**ZONING AMENDMENT
& SUBDIVISION STAFF REPORT****Date: April 20, 2017****APPLICANT NAME**

DSG Fields Subdivision

Subdivision approval to relocate the interior lot line
between 2 metes-and-bounds parcels, and Zoning approval
to re-zone the site from R-1, Single-Family Residential
District, and B-1, Buffer District, to B-1, Buffer Business
District, to eliminate split-zoning.

SITE PLAN

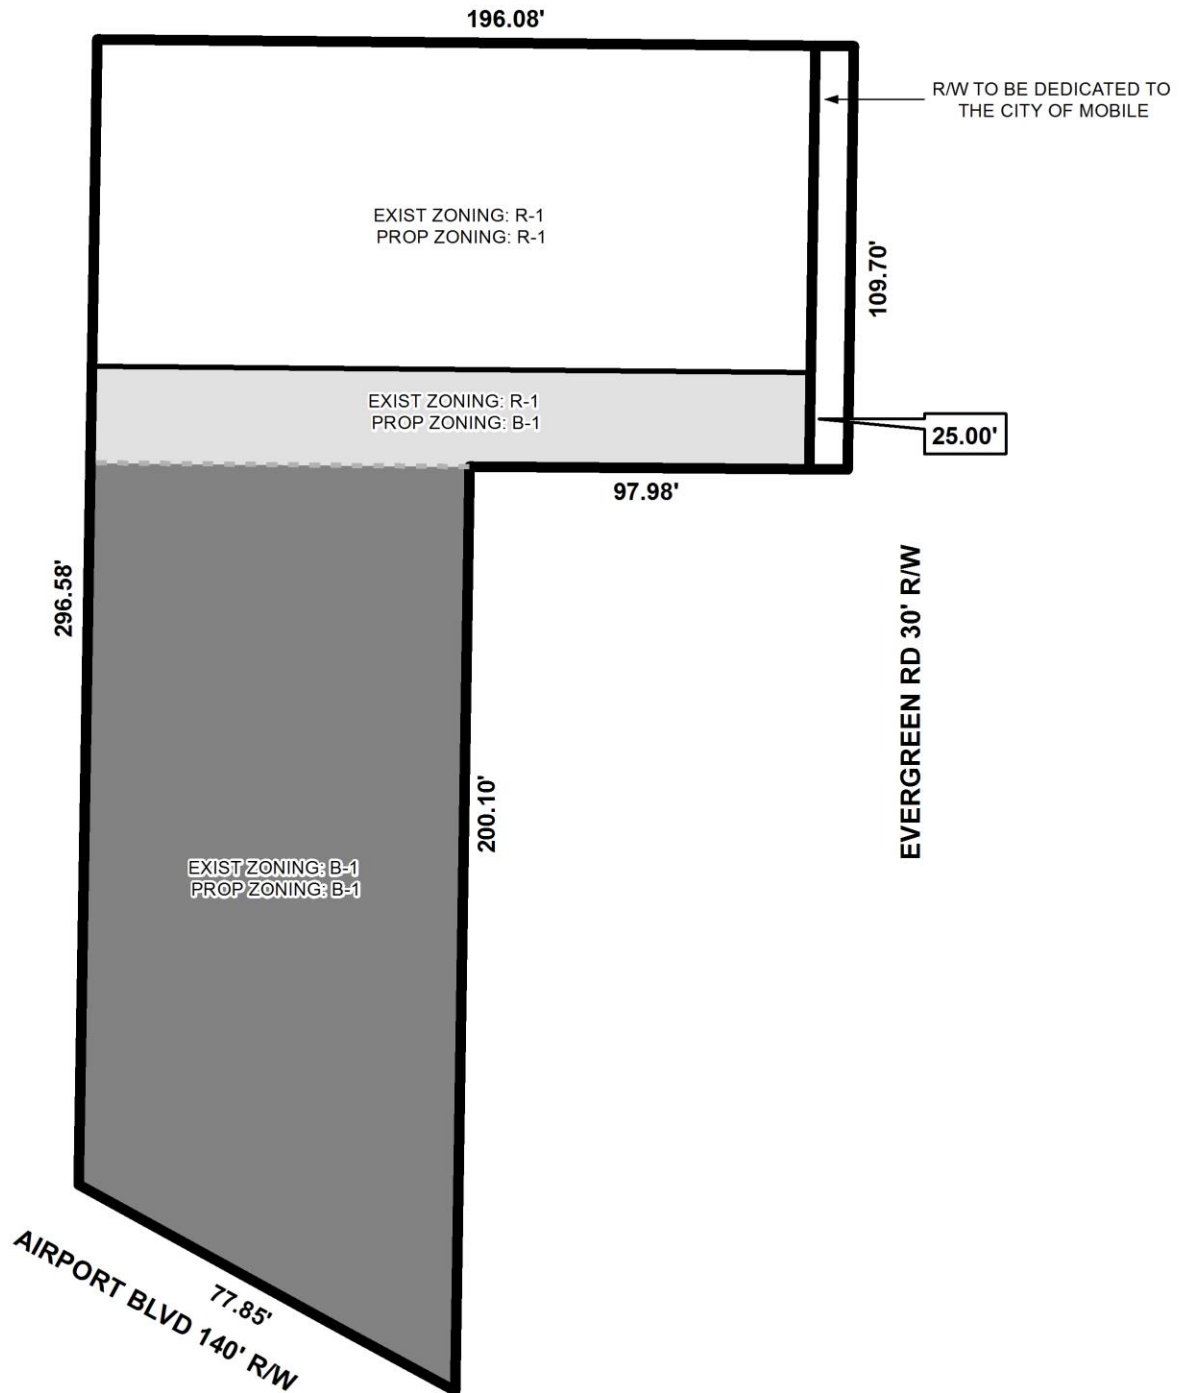
The applicant proposes to adjust an interior property line between the existing parcels to provide proposed Lot A with frontage along Evergreen Road. Doing so reduces the width of proposed Lot B, and results in the split-zoning of proposed Lot A.

Proposed Lot A is irregularly shaped, with 77.85'± of frontage along Airport Boulevard, a major street per the Major Street Plan, requiring 100' of right-of-way; and, 25'± of frontage along Evergreen Road, a minor street without curb and gutter requiring 60' of right-of-way. Proposed Lot B has 84.71'± of frontage along Evergreen Road. The preliminary plat illustrates sufficient right-of-way along Airport Boulevard, but not along Evergreen Road; and, as such, should be revised to illustrate dedication sufficient to provide 30' from the centerline of Evergreen Road, if approved.

Lot A, as proposed, would result in a design which may be regarded as a "panhandle" lot. The subdivision would also result in a maximum depth greater than 3.5 times the width of proposed Lot A at the building setback line along Airport Boulevard. Such designs are generally discouraged by Sections V.D.1. and V.D.3. of the Subdivision Regulations, respectively; the exception being the approval of lots located where varied and irregularly-shaped lot designs are common, and the informality of design is consistent with other lots in the vicinity. The Planning Commission has not approved similarly-shaped lots in the immediate vicinity, therefore waivers of Sections V.D.1. and V.D.3 would be required, if approved.

With regards to access management, there is concern from Traffic Engineering that access to Lot A from Evergreen Road would be substandard considering commercial driveway standards could not be met by a 25' frontage width. If approved, a note should be placed on the Final Plat stating each lot is limited to one curb cut per street frontage, with any changes in their sizes, designs, or locations to be approved by Traffic Engineering and conform to AASHTO standards.

The site plan provided by the applicant is a duplicate of the preliminary plat, with the exception of the illustrated zoning districts. As the applicant mentions, Lot A is undeveloped and no new building construction is proposed at this time; however, Lot B is developed with a single-family dwelling. If approved, the proposed re-subdivision of Lot B does not appear to affect the property with respect to building site compliance.

Subdivision: Based on the preceding the plat is recommended for Denial due to the following:

- 1) proposed Lot A does not comply with Sections V.D.1. or V.D.3. of the Subdivision Regulations;
- 2) the subdivision would result in substandard access to proposed Lot A from Evergreen Road; and,
- 3) approval of the subdivision would result in lots out of character with the surrounding area.
